PRELIMINARY REVIEW AND EVALUATION OF THE MILLSTONE-3
PROBABILISTIC SAFETY STUDY

M. Khatib-Rahbar, H. Ludwig, and W. T. Pratt

December 19, 1983

U.S. Nuclear Regulatory Commission
Washington, D. C. 20555
Contract No. DE-AC02-76CH00016
FIN No. 3748

Figure 2.1 Schematics of the containment cooling systems in the Millstone-3

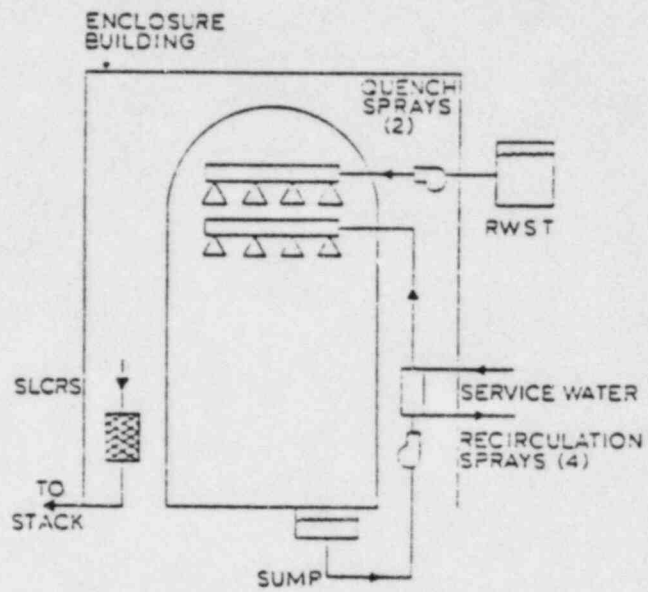
The absence of fan coolers in the Millstone plant can also effect the accident progression and containment pressurization effects.

Figure 2.2 Schematics of the lower reactor cavity in the Millstone-3

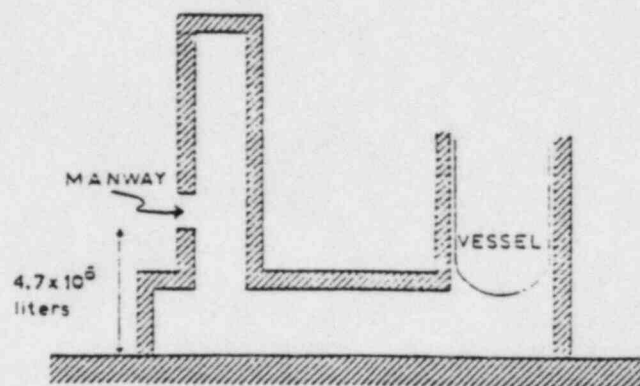
The containment geometry design in the area underneath and around the reactor vessel precludes water from entering the reactor cavity area until a major portion of the Refueling Water Storage Tank (RWST) has been exhausted via the quench spray system (see Figure 2.2). This is referred to as a dry cavity configuration. The same geometry is expected to preclude the dispersion of core debris from the reactor cavity to the general containment area following postulated failure of the reactor vessel during core melt sequences. The cavity area geometry also would preclude the establishment of effective convective air currents between the cavity and general containment area for heat removal of core debris in the reactor cavity area. The containment design also includes a permanent seal ring between the reactor vessel flange and the biological shield walls, which would prevent introduction of water into the reactor cavity from either break flow or spray flow in the area of the reactor vessel or the refueling cavity. The containment building basemat and the internal concrete structures are composed of basaltic-based concrete.

These inherent design differences are expected to alter the course of the accident sequences; in particular, following failure of the reactor vessel, where the containment pressurization is significantly influenced by the debris bed coolability and water availability.

Figure 3.1 The MPSS computational approach.

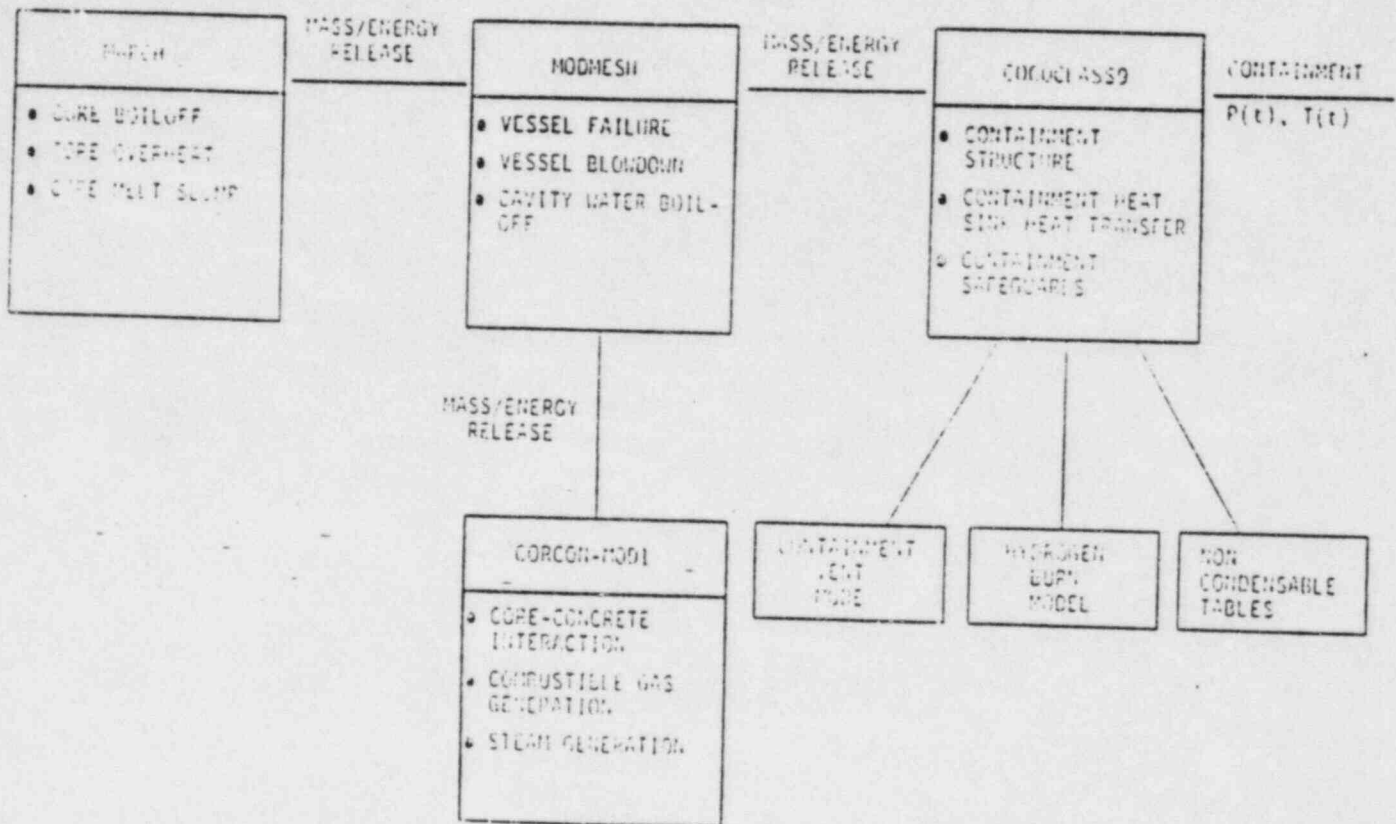
Table 3.1 summarizes the code package as applied to various phases of the accident. It is seen that the MARCH code is used to model the core and primary system behavior and to obtain the steam and water energy releases for (1) the entire transient in the case of non-dispersal accident events and (2) until the vessel failure for the dispersal scenarios. These mass and energy releases form the input for the other computer codes used to evaluate the containment response for the non-dispersal cases (see also Figure 3.1).

This preliminary review of the approach used in the MPSS for quantification of core and containment response is directed to a review of the consistency of the approach. However, detailed verification of the results obtained in the MPSS cannot be made at this stage, and is thus deferred to a later date.
